# UNITED STATES PATENT AND TRADEMARK OFFICE

APPLICATION NO.	FILING DATE	FIRST NAMED INVENTOR	ATTORNEY DOCKET NO.	CONFIRMATION NO.
10/622,751	07/18/2003	Matthew David Tarler	CMD-006	3135

**Office Action Summary**

## Final Rejection

Fig. 6B

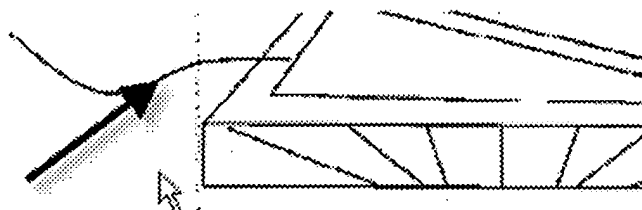
3. The drawings are objected to because all the elements in the figures are not labeled. For example,

Corrected drawing sheets in compliance with 37 CFR 1.121(d) are required in reply to the Office action to avoid abandonment of the application. Any amended replacement drawing sheet should include all of the figures appearing on the immediate prior version of the sheet, even if only one figure is being amended. The figure or figure number of an amended drawing should not be labeled as "amended." If a drawing figure is to be canceled, the appropriate figure must be removed from the replacement sheet, and where necessary, the remaining figures must be renumbered and appropriate changes made to the brief description of the several views of the drawings for consistency. Additional replacement sheets may be necessary to show the renumbering of the
